REPORT TO THE CALGARY PLANNING COMMISSION

DEVELOPMENT PERMIT	ITEM NO: 16	
	CPC DATE:	2009 April 16
	DP NO:	DP2008-2280

PROPOSAL: 5 storey multi-residential development

APPLICANT: Manu Chugh Architect	OWNER: G5 Ventures Inc.
MUNICIPAL ADDRESS: 607 17 Av NW	LEGAL DESCRIPTION: Plan 2934O, Block 2, Lots 31-40 (Map 28C)
EXISTING LAND USE DISTRICT(S): M-C2 Multi-Residential - Contextual Medium Profile	
AREA OF SITE: 0.28 ha □ (0.69 ac □)	
CURRENT DEVELOPMENT: Existing Low-Density Residential, surface parking lot

A1.1
 PLAN

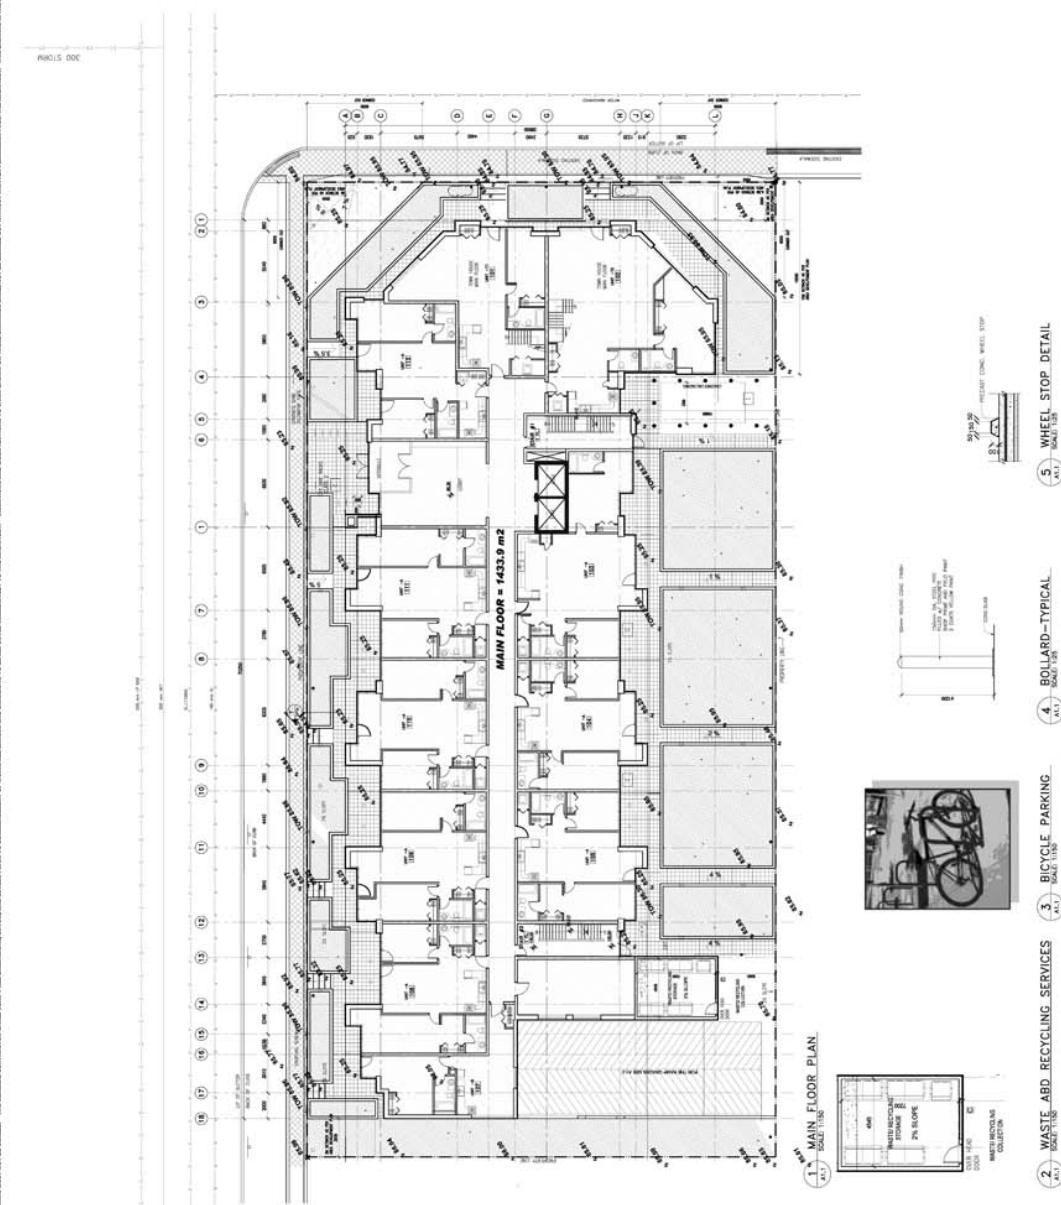
- a. Plans are not scalable (See A1.1).
 - b. Label and dimension waste container access door (minimum 3 meter wide x 2.1 meters in height).
 - c. Indicate, label and dimension on the plans, the "Waste Staging" area.
 - d. Indicate and note on the plans, that the "Waste Staging" area is reinforced concrete able to support a minimum of 25,000kg and that it is flush with the lane. Lane patching may be required
 - e. Contact the Waste and Recycling Services, Technical Assistant at 230-6646 for further site specific details.
3. Remit a performance security deposit (certified cheque, bank draft, letter of credit) for the proposed infrastructure listed below within the public right-of-way to address the requirements of the Business Unit. The amount of the deposit is calculated by Roads and is based on 100% of the estimated cost of construction.

NORTH & SOUTH ELEVATIONS

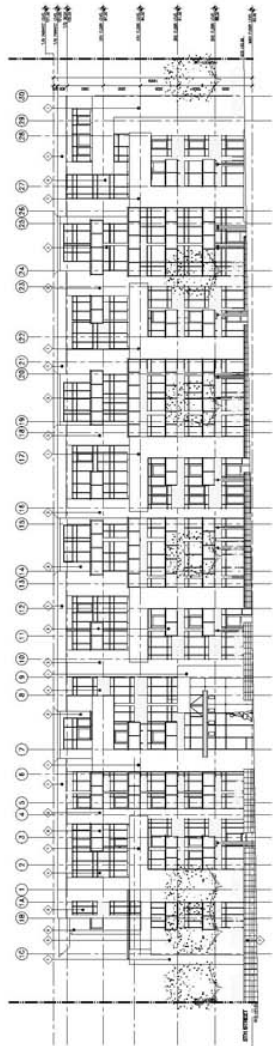
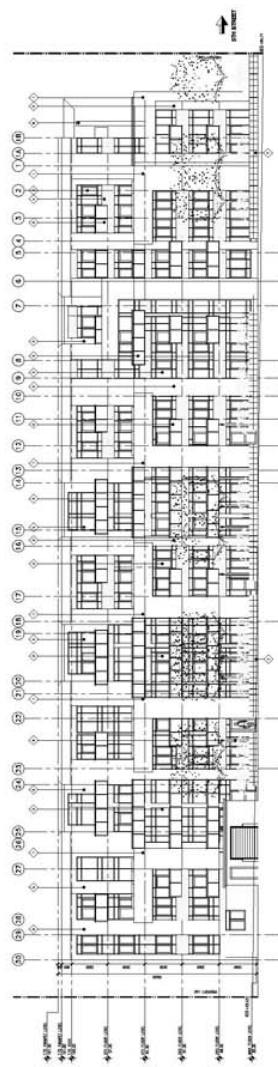
A Bylaw relaxation is required for the height of the building. The elevation drawings indicate a small portion of the building exceeds the maximum height of 16 metres by 0.05 metres. This application complies with the horizontal cross section of the ARP, thus a relaxation for the Land Use Bylaw is required.
